OUTSTANDING DESIGN CONCERNS

PREVIOUS LUR 1 SUBMISSION - NORTH LANDSCAPE SITE PLAN: WHAT WE HEARD

LUR 2 - NORTH LANDSCAPE SITE PLAN RESPONSE

PREVIOUS LUR 1 SUBMISSION - SOUTH LANDSCAPE AXONOMETRIC: WHAT WE HEARD

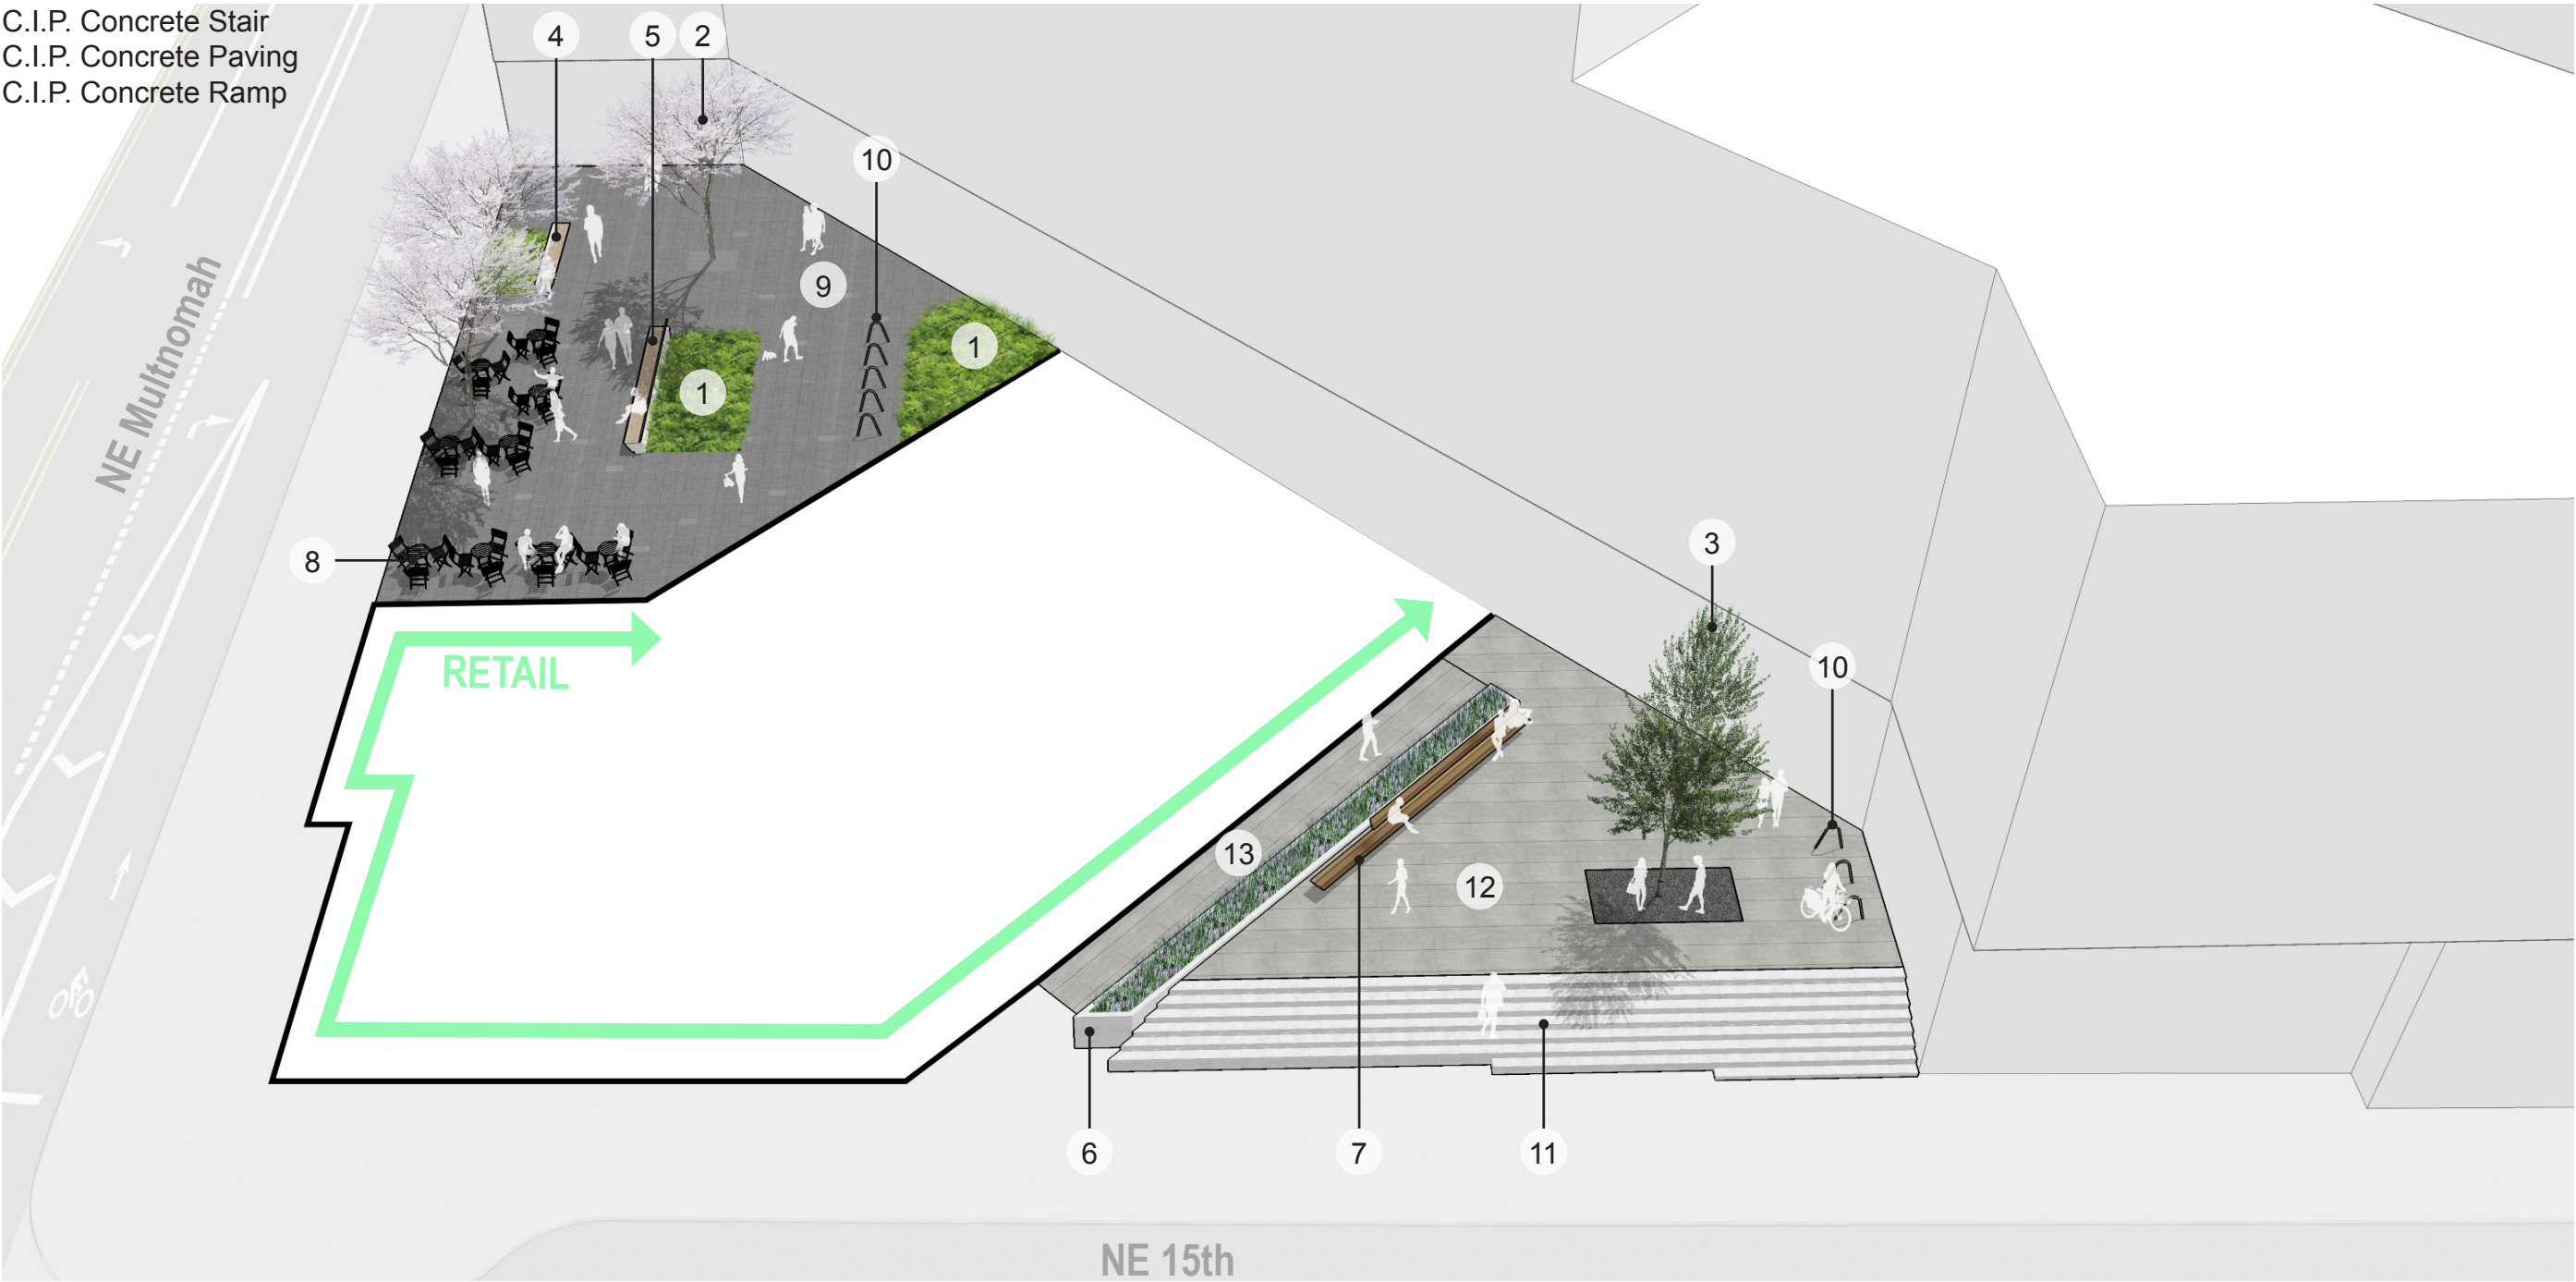
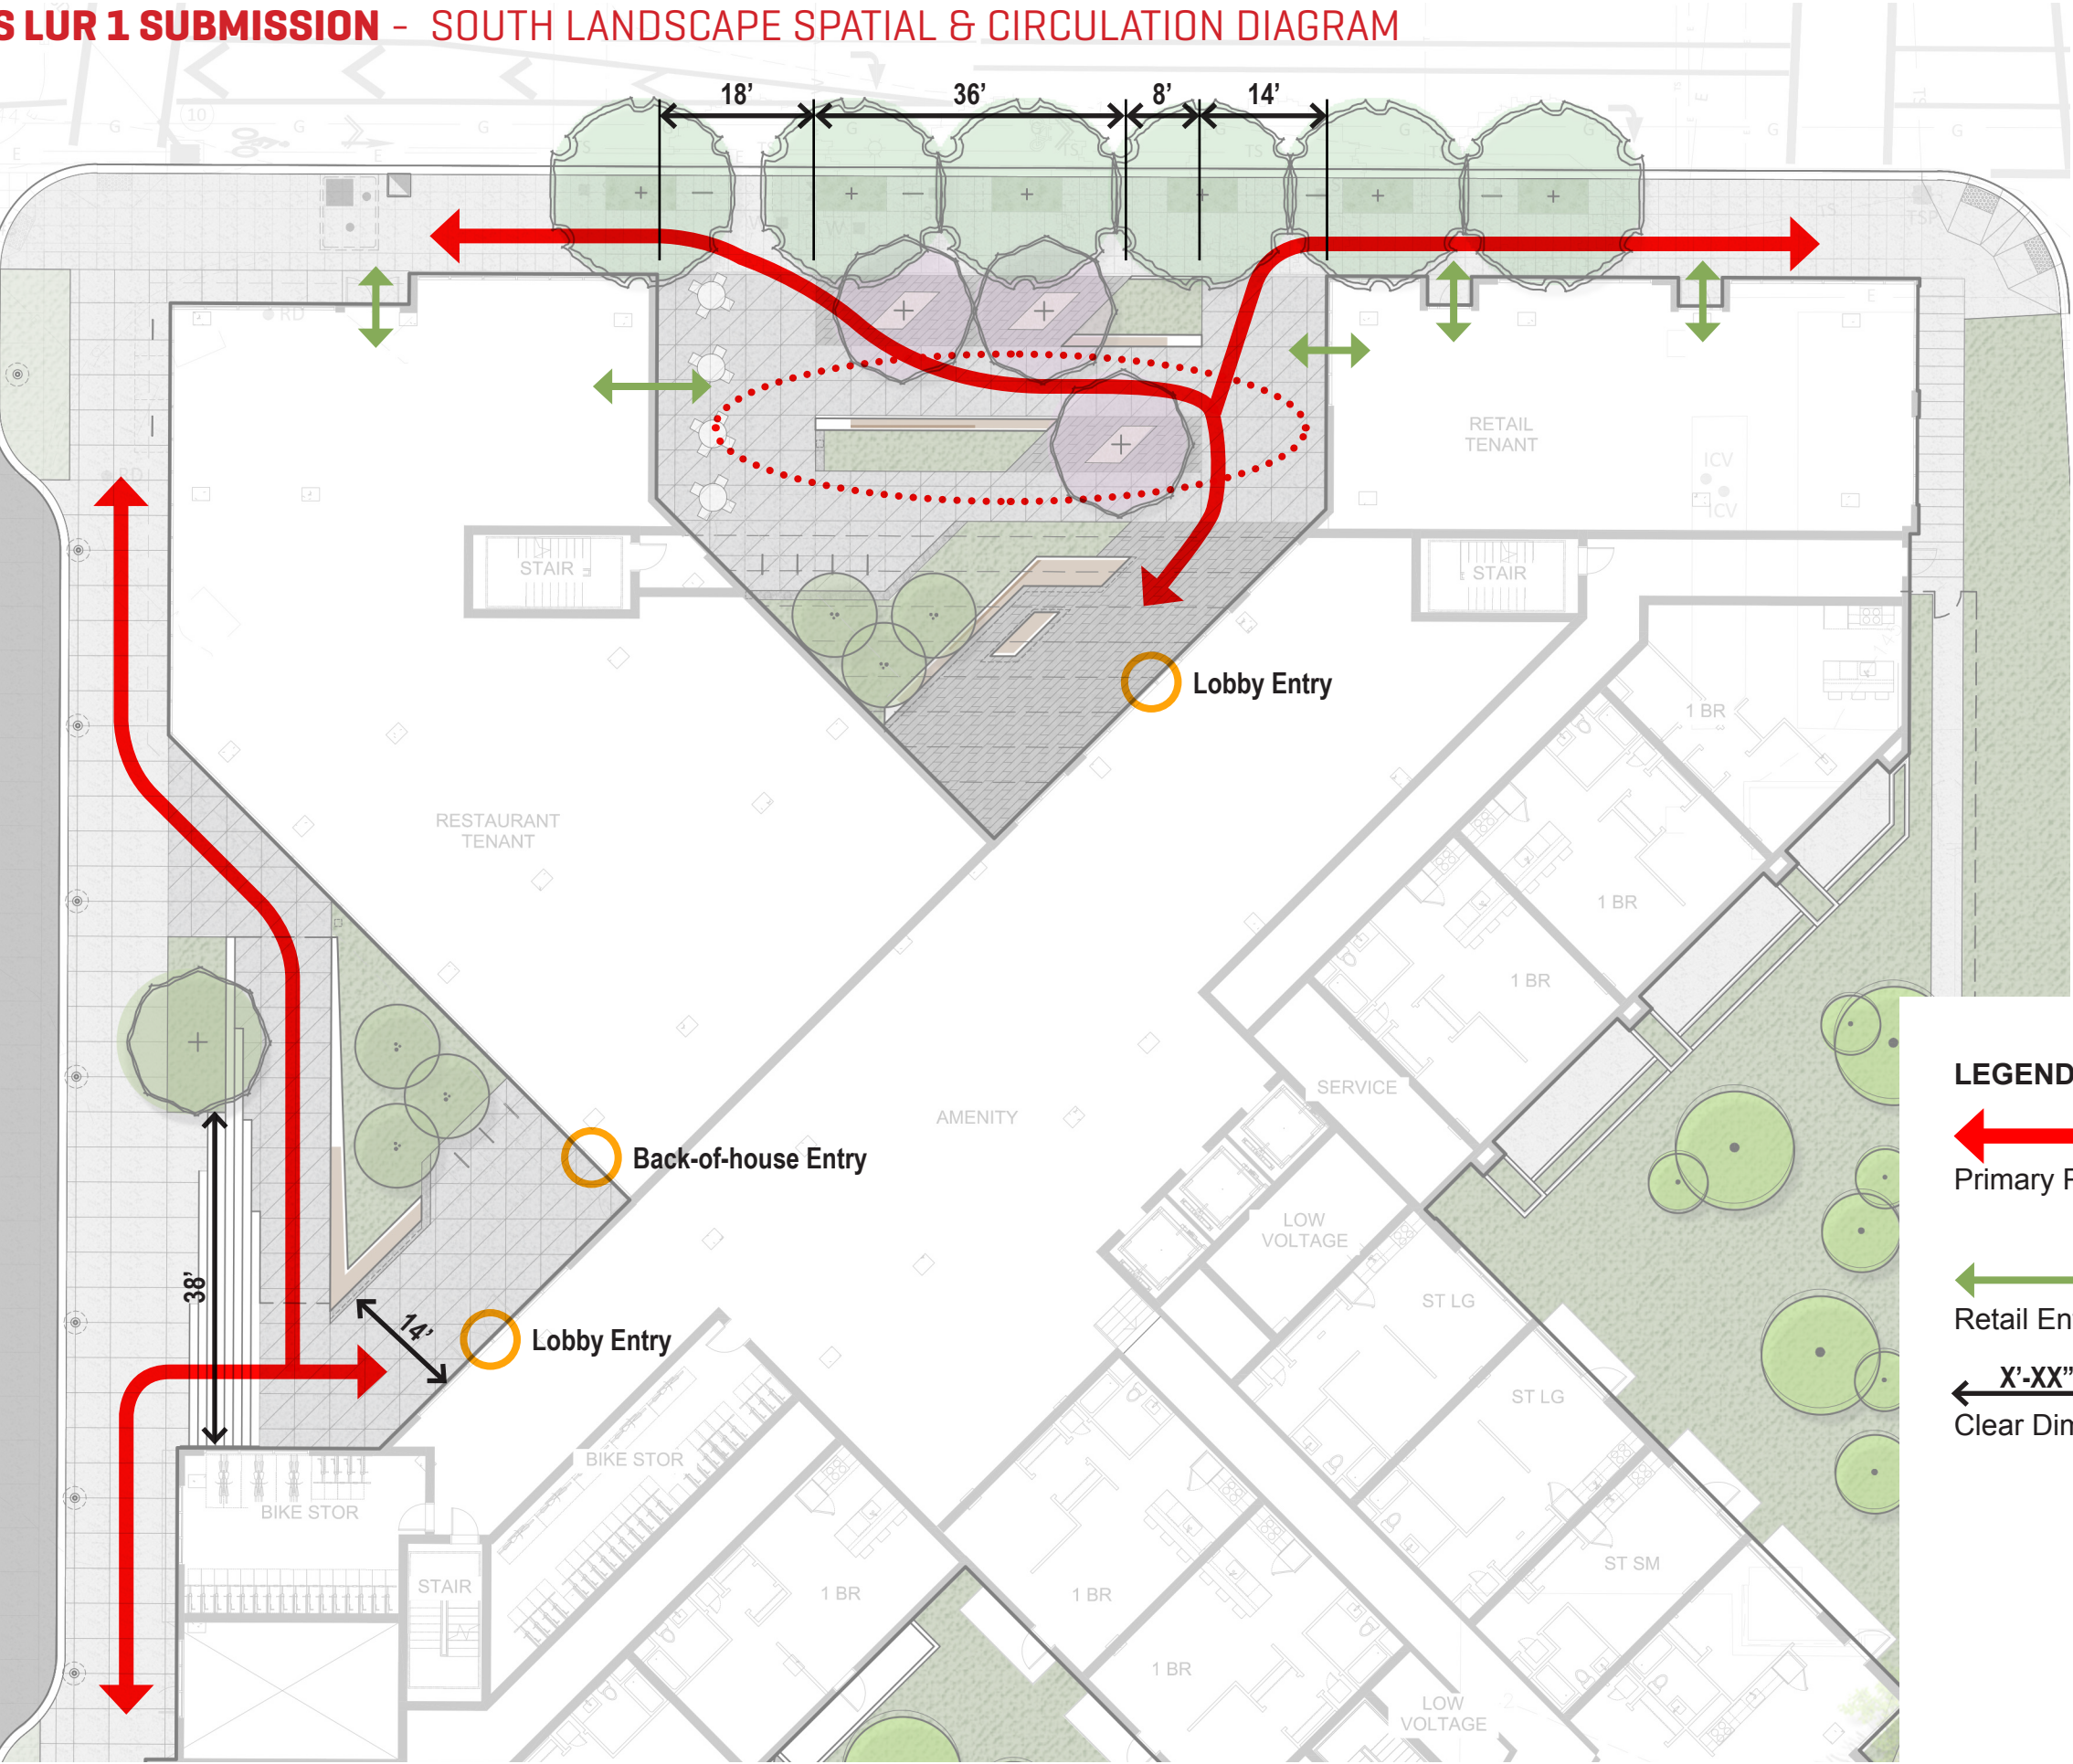
URBAN PLANE PLAZA
Courtyard layout and language doesn't seem quite 'baked'. Landscape design feels too tied to the geometry of the building - investigate some flexibility with layout language. Keep the benches.

PLATEAU PLAZA
Circulation path to Lobby seems too indirect. Linear bench feels like an obstacle and too sharp. Landscape design feels too tied to the geometry of the building - investigate some flexibility with layout language.
